# Access Compliance Report

## Public Rights-of-Way

Intersection ID: 18541	Main Street: PROVIDENCE_RD	Cross Street: WESTBURY_RD	Location:	N
ADA ID: 5EF4BBA4CB15	Ramp Type: Perp	Initial Pass/Fail: Fail	Overall Compliance: No	Severity Score: 21.25
Codes/Mitigation Info/Possible Solution		Field Measurements/Component Compliance

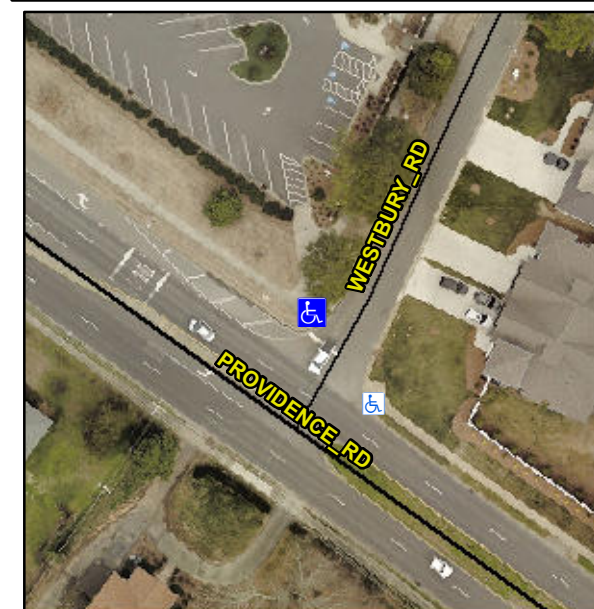
**Not Found, R304.5.1, R304.2.2**

Compliance	Description	Data	Compliance	Description	Data
N/A	Ramp Length (in)	57.0	No	Ramp Slope (%)	8.9
No	Ramp Width (in)	45.0	Yes	Ramp XSlope (%)	0.5
N/A	Flare Type LT	N/A	N/A	Flare Type RT	N/A
N/A	Flare Slope LT (%)	N/A	N/A	Flare Slope RT (%)	N/A
N/A	Flare Traversable LT?	N/A	N/A	Flare Traversable RT?	N/A
N/A	Landing Length (in)	N/A	N/A	DWS Provided?	N/A
N/A	Landing Width (in)	N/A	N/A	DWS Contrast?	N/A
N/A	Landing Slope (%)	N/A	N/A	DWS Length (in)	N/A
N/A	Landing X Slope (%)	N/A	N/A	DWS Full Width?	N/A
N/A	Landing Curb? (Y/N)	N/A	N/A	DWS Offset (in)	N/A
N/A	Shared Landing?	N/A			
N/A	Gutter Ponding?	N/A	N/A	Gutter Slope (%)	N/A
N/A	Gutter Lip Ht (in)	N/A	N/A	Gutter X Slope (%)	N/A
N/A	Painted X Walk1?	No	N/A	Painted X Walk2?	N/A
	X Walk 1 Direction	To SE		X Walk 2 Direction	N/A
N/A	X Walk 1 Width (in)	N/A	N/A	X Walk 2 Width (in)	N/A
	X Walk 1 Slope (%)	4.9		X Walk 2 Slope (%)	N/A
	X Walk 1 X Slope (%)	2.2		X Walk 2 X Slope (%)	N/A

**Remove & Replace Entire Ramp.**
